POST CONSTRUCTION INSPECTION REPORT OF RADAR TOWERS

SITE: LANDRIENNE RADAR

ENVIRONMENT CANADA

MCA REFERENCE N°: 1642-100-1

photo # 5

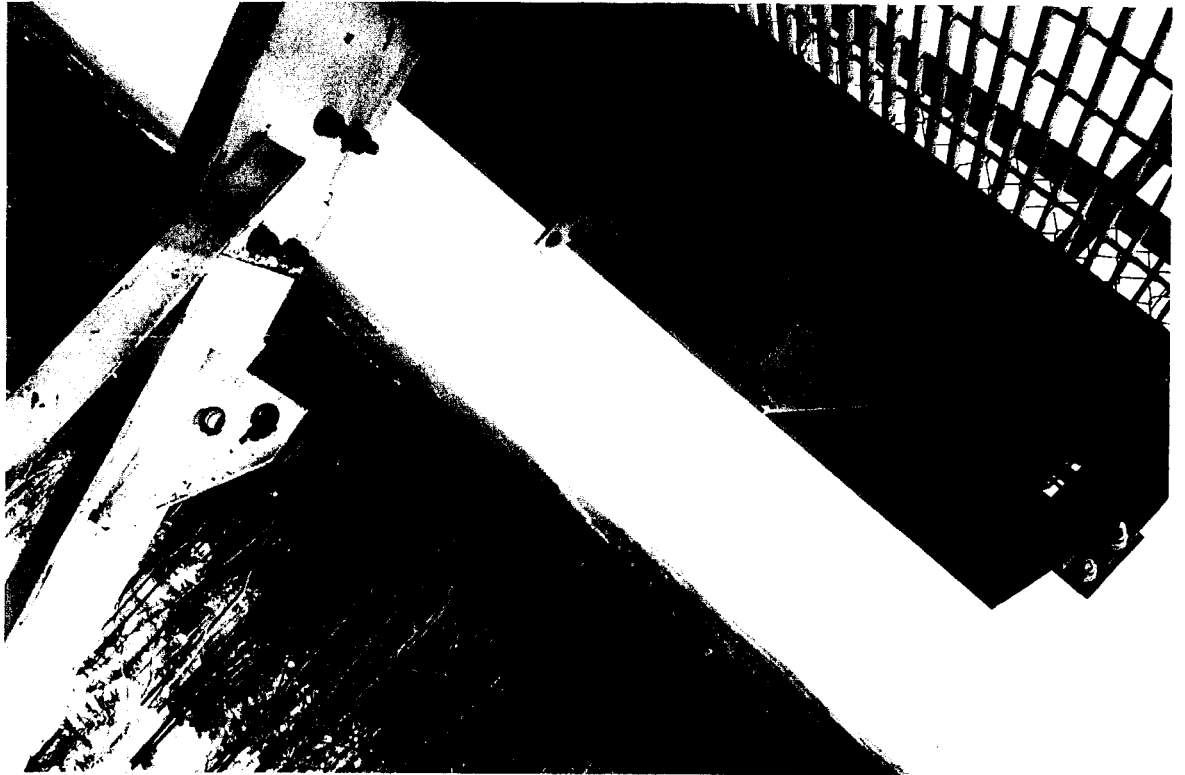
- 7.3 Three diagonal members are missing under the catwalk at elevation 21 m (Photo no. 5). We recommend installing these members.
- 7.4 There are two damaged secondary horizontal members on the tower (Photo no. 6). We recommend replacing them.

photo # 8

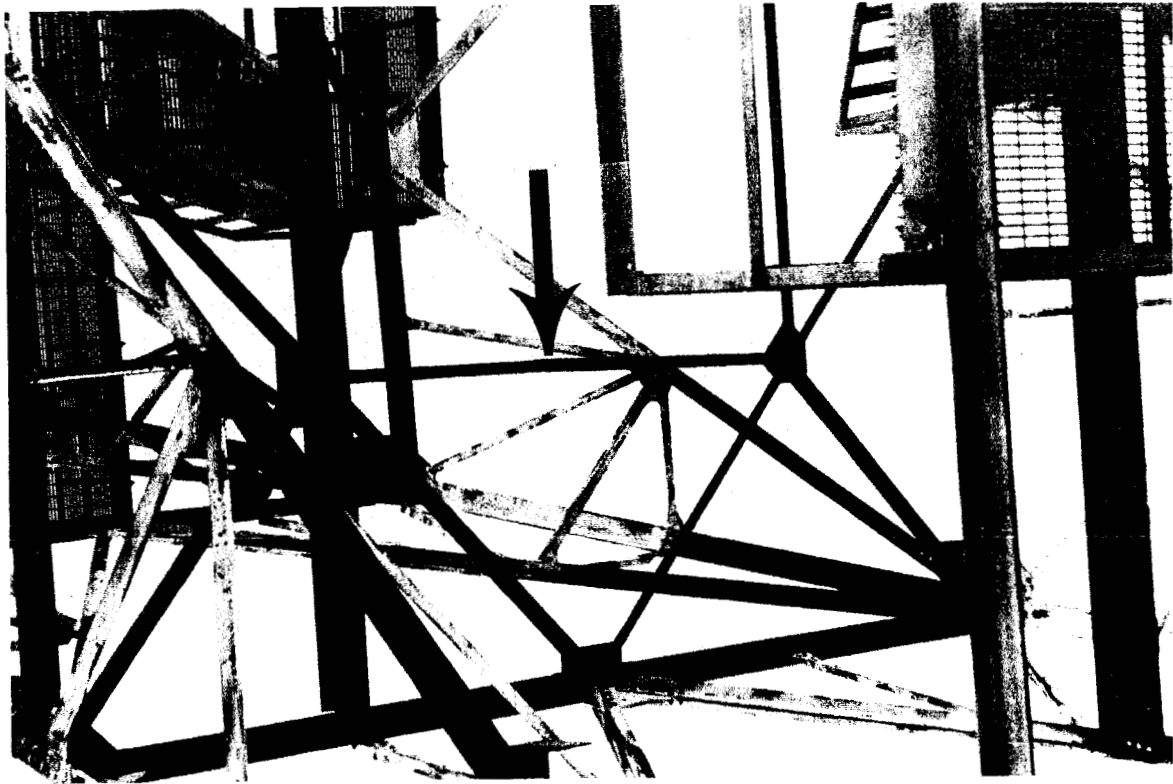
- 7.6 The interior bracing member parallel to face 4 at elevation 12.6 m is bent (Photo no. 8). We recommend replacing this member.
- 7.7 There are numerous openings in the steel wire woven mesh at the platform levels (Photo no. 9). We recommend rectifying the situation.

photo # 13

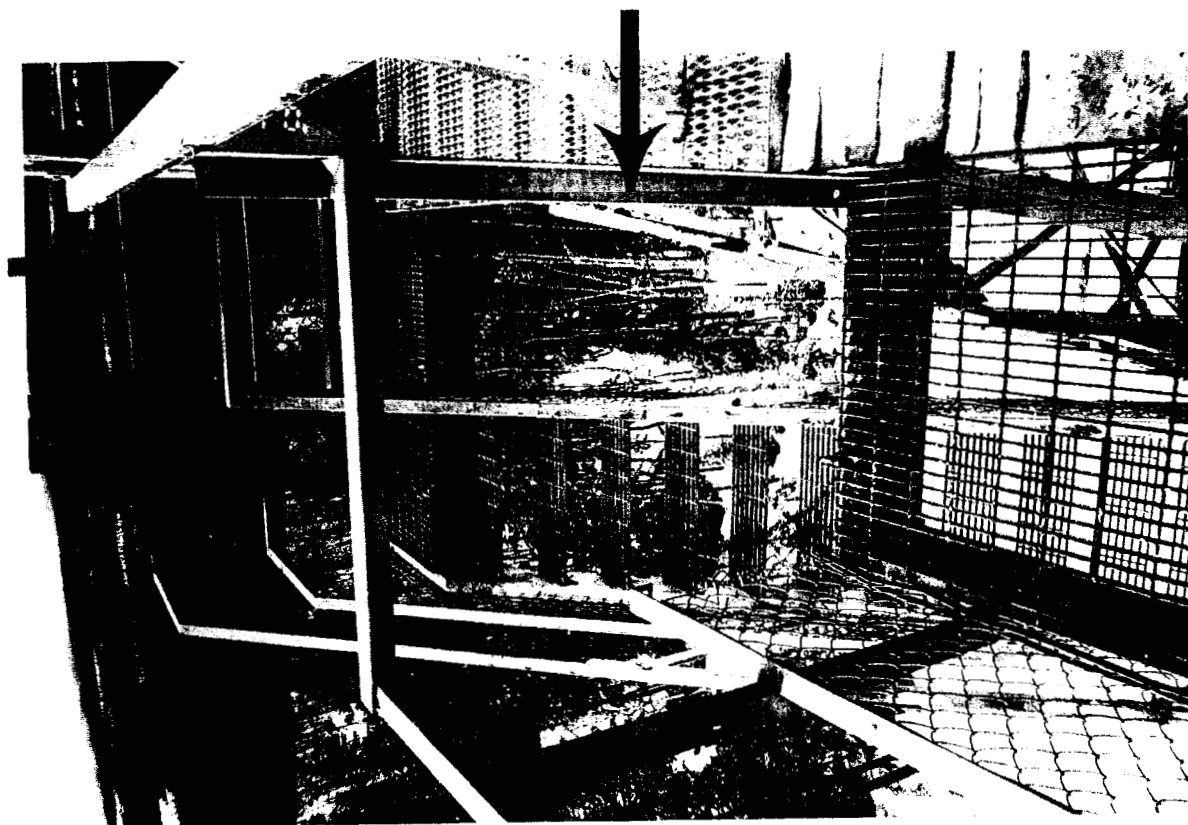
- 7.10 On the last catwalk level, a section of the handrail is too low and one mid-span member is missing (Photo no. 13). We recommend rectifying the situation.

photo # 20

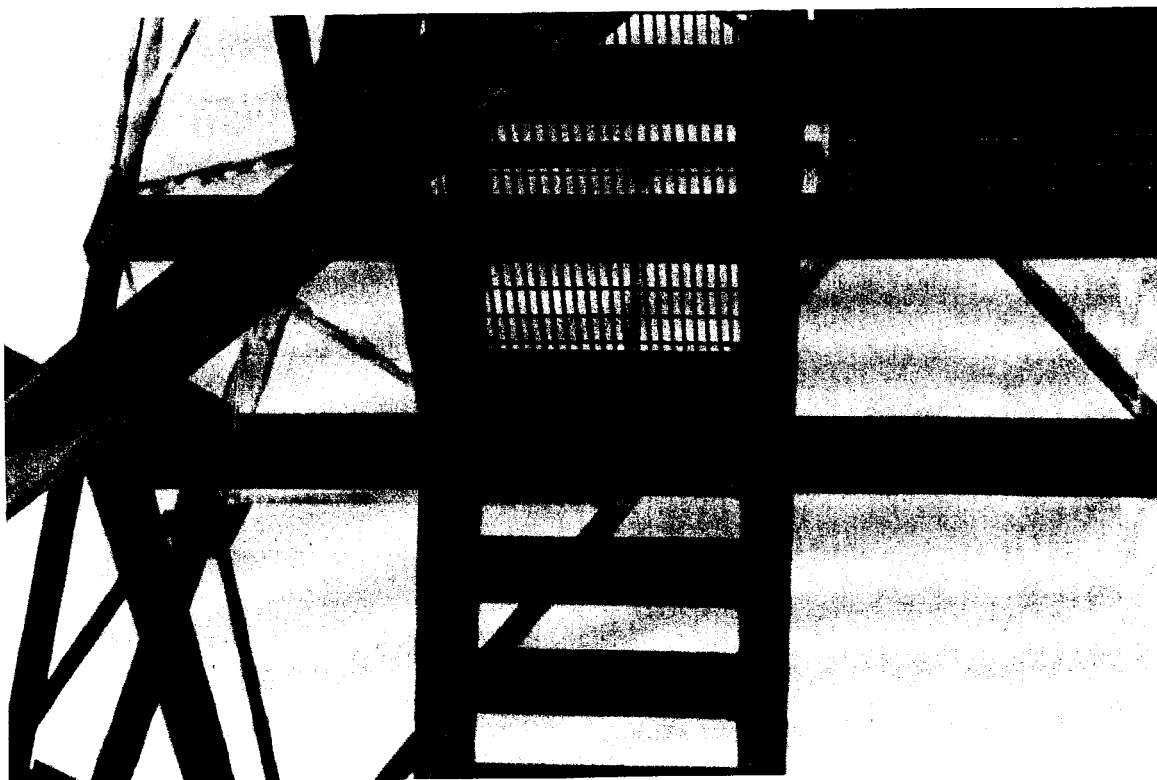
- 8.3 Some spacers are missing at stitch bolts locations at elevation 6 m \pm (Photo no. 18 and 19). We recommend rectifying the situation.
- 8.4 The stair section between the ground and elevation 6 m is not properly attached to the platform, two bolts are missing (Photo no. 20). We recommend rectifying the situation.
